ACCESSION NBR: 8303250015 DOC. DATE: 83/03/21 NOTARIZED: NO DOCKET #
 FACIL: 50-331 Duane Arnold Energy Center, Iowa Electric Light & Pow 05000331
 AUTH. NAME AUTHOR AFFILIATION
 ROOT, L.D. Iowa Electric Light & Power Co.
 RECIP. NAME RECIPIENT AFFILIATION
 DENTON, H.R. Office of Nuclear Reactor Regulation, Director

SUBJECT: Responds to NRC 830117 request for addl info re TMI
 Items II.F.1.4, II.F.1.5 & II.F.1.6. Descriptions of
 containment pressure, water level & hydrogen monitoring sys
 encl & document compliance w/requirements of NUREG-0737.

Subject: Duane Arnold Energy Center
Docket No.: 50-331
Op. License No. DPR-49
NUREG 0737, Items II.F.1.4, II.F.1.5, II.F.1.6
Response to NRC Request for Additional Information

DUANE ARNOLD ENERGY CENTER
RESPONSE TO NRC REQUEST
FOR ADDITIONAL INFORMATION ON NUREG 0737 ITEMS

BLOCK DIAGRAM (REDUNDANT SYSTEMS APPLICABLE)

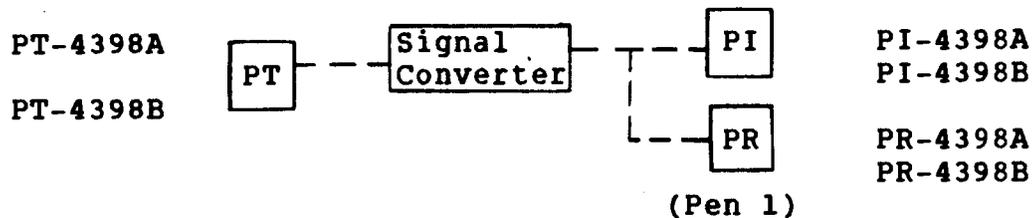
Provide a block diagram of the configuration of modules that make up your PMS. Provide an explanation of any details in the block diagram that might be necessary for an understanding of your PMS accuracy and time response.

BLOCK DIAGRAM (REDUNDANT SYSTEMS APPLICABLE)

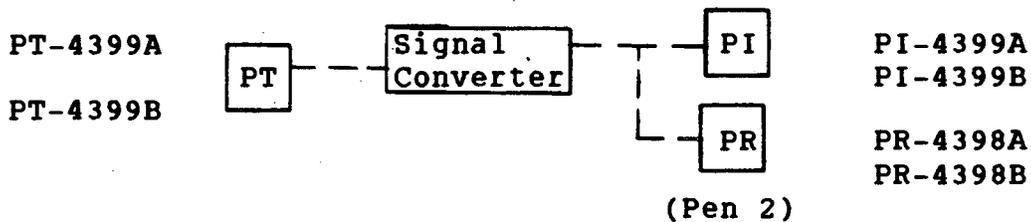
Provide a block diagram of the configuration of modules that make up your PMS. Provide an explanation of any details in the block diagram that might be necessary for an understanding of your PMS accuracy and time response.

BLOCK DIAGRAM (REDUNDANT SYSTEMS APPLICABLE)

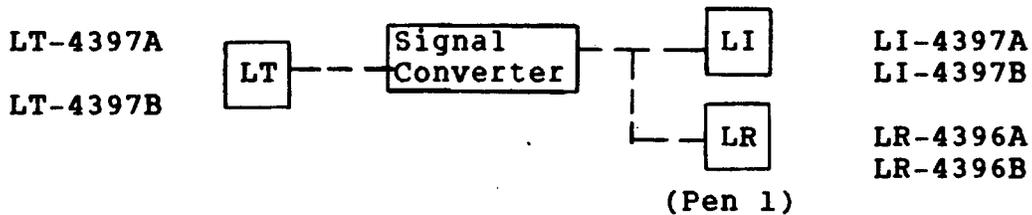
Provide a block diagram of the configuration of modules that make up your WLMS. Provide an explanation of any details in the block diagram that might be necessary for an understanding of your WLMS accuracy.

BLOCK DIAGRAM (REDUNDANT SYSTEMS APPLICABLE)

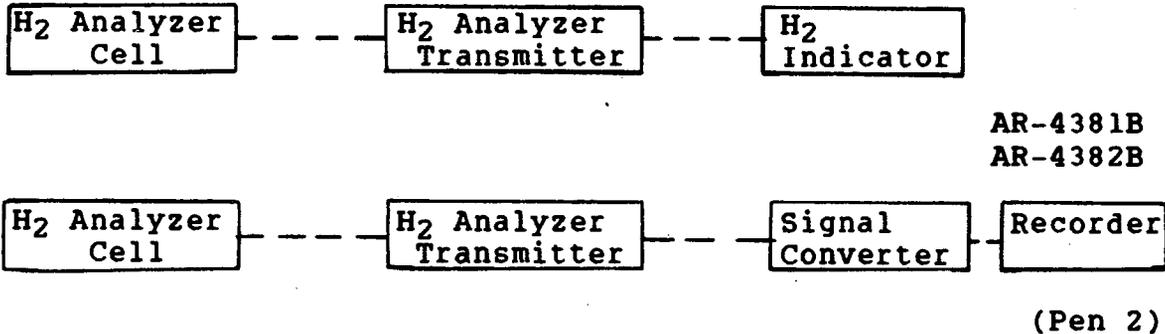
Provide a block diagram of the configuration of modules that make up your HMS. Provide an explanation of any details in the block diagram that might be necessary for an understanding of your HMS accuracy. If you have different types of HMSs give this information for each type.
